# Overshoot and Tx Power Excursion

(in support of comments 179 and 180)

IEEE P802.3db 100 Gb/s, 200 Gb/s, and 400 Gb/s Short Reach Fiber Task Force  
TF Plenary Meeting, Nov 11, 2021

# Observations

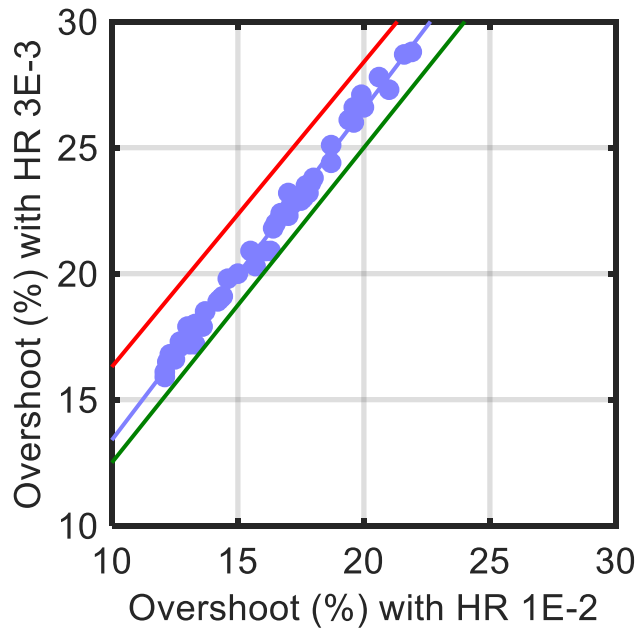
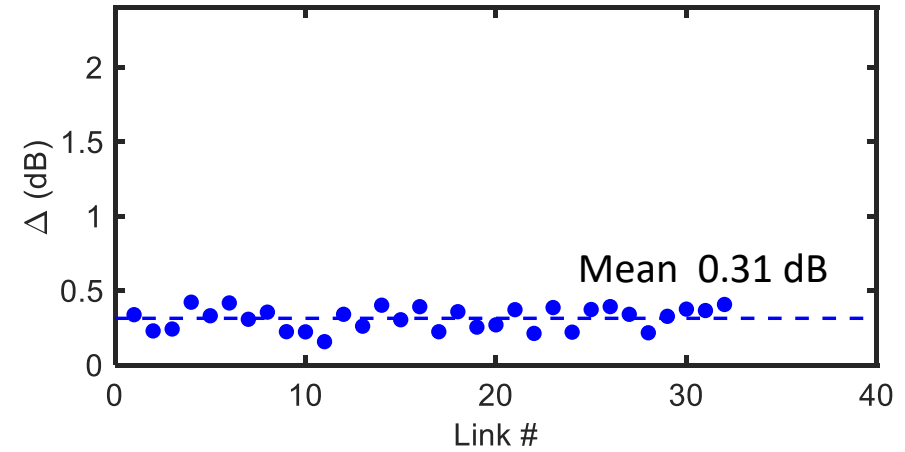
- Overshoot/undershoot is maximum at short length (2 m) and decreases with fiber length because fiber acts as a low pass filter.
- Transceivers have to pass overshoot/undershoot (at 2m), TECQ, and TDECQ with the same drive setting. Passing TDECQ requires more pre-emphasis leading to more overshoot/undershoot at 2 m.
- Photodiode responsivity at 850 – 940 nm is smaller than 1310 nm leading to a smaller current swing into the TIA.
- Overshoot is specified using a hit ratio, and there is a correlation between the values at different hit ratios. In D2.0, overshoot/undershoot (max) is 26% at 3E-3 hit ratio which is equivalent to 20% at 1E-2 hit ratio. Hit ratio is 3E-3 in 802.3db D2.0 and 1E-2 in 802.3cu.
- This comment (#179) proposes overshoot/undershoot (max) of 29% at 3E-3 HR, equivalent to 22% at 1E-2 HR defined in 802.3cu.

# Overshoot

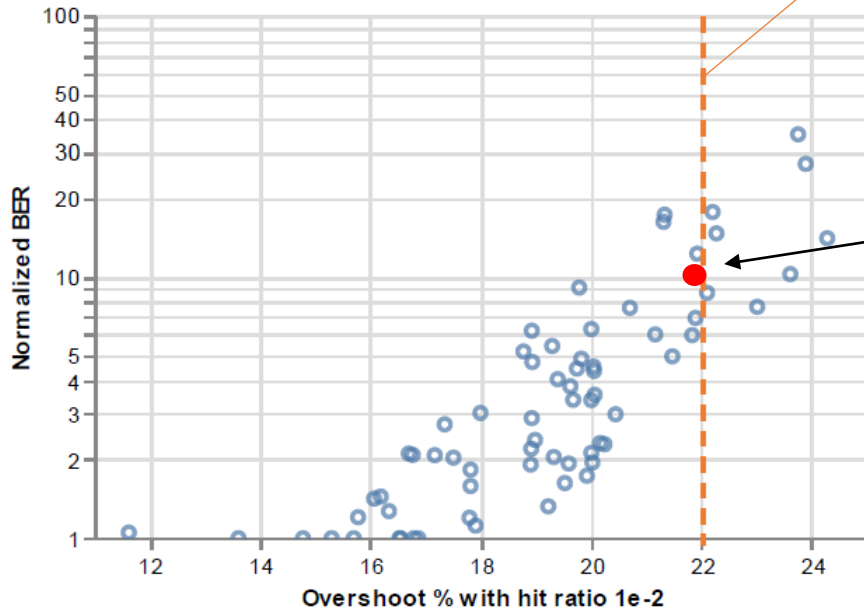
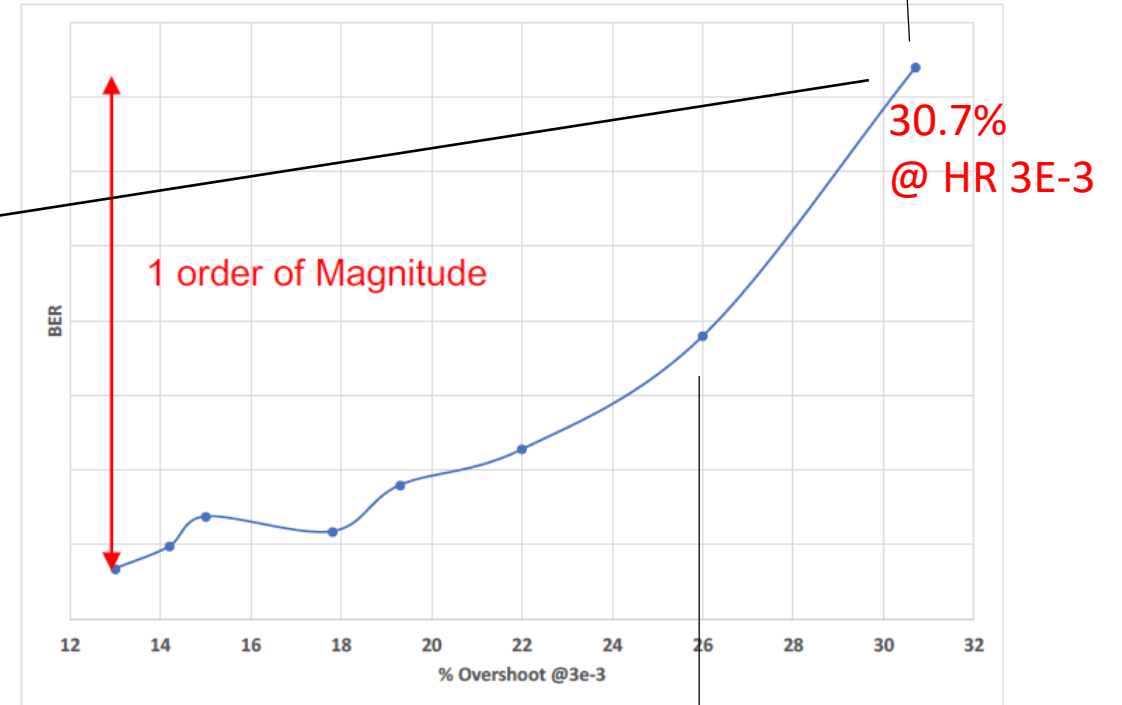
Lies within the population permitted in P802.3cu

30.7% @ HR 3E-3

26% max (D2.0) overshoot/undershoot

We propose a 22% spec to limit the penalty on error floor while allowing some overshoot margin for:

- Manufacturing margin
- Measurement error
- Over temperature and dispersion penalty

# TDECQ vs. Overshoot

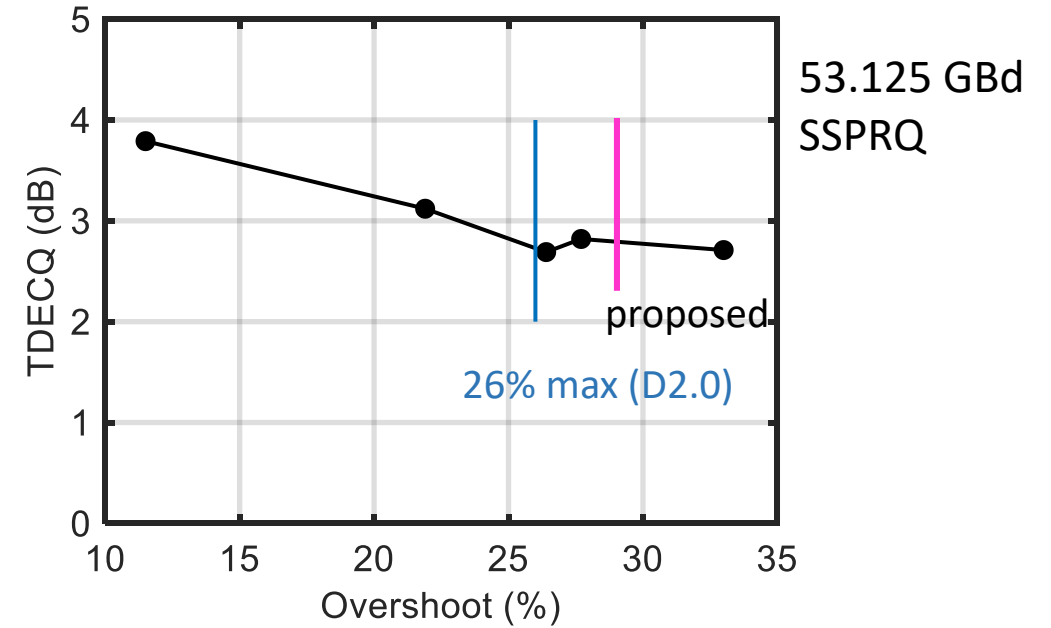
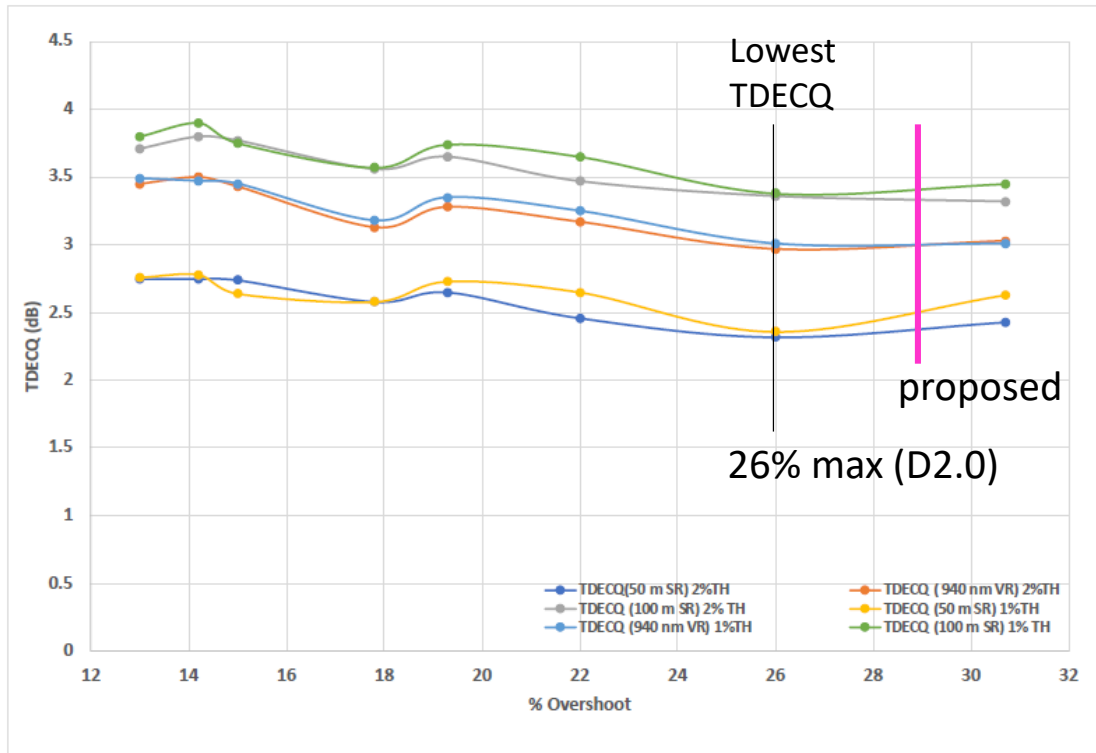
- Accessing the drive condition for lowest TDECQ requires having some margin on the set point.

- Proposal for overshoot/undershoot (max): 29% @ HR 3E-3 [equivalent to 22% @ HR 1E-2]
